Product Change Notification

Change Notification #: 113527 - 00
Change Title: Intel® Server System R1304GZ4GC
PCN 113527-00,
Product Design, Label
Update the Quick Reference Label and
BIOS/ME/BMC/FRUSDR Firmware
Date of Publication: December 17, 2014

Intel is implementing the following changes on the Intel® Server System R1304GZ4GC:

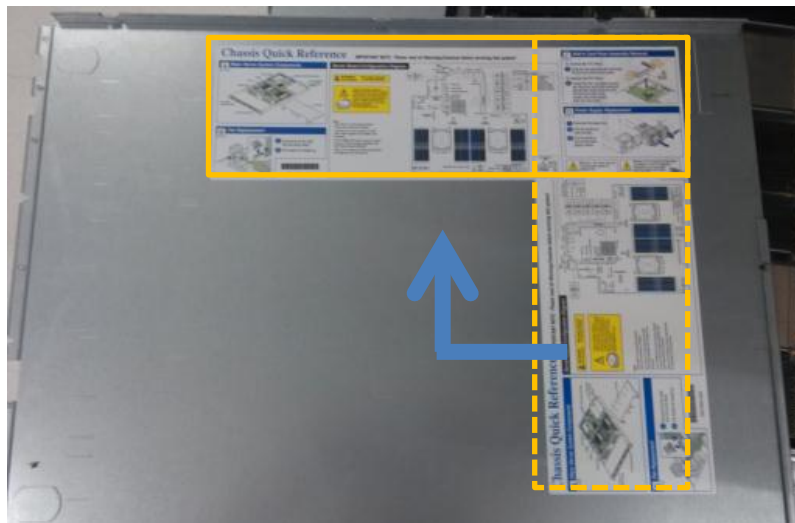
1. Rotate the orientation of the Quick Reference Label by 90 degree. The new location of the label is above the power supply unit cage and the air duct. Please see the figure below for reference.
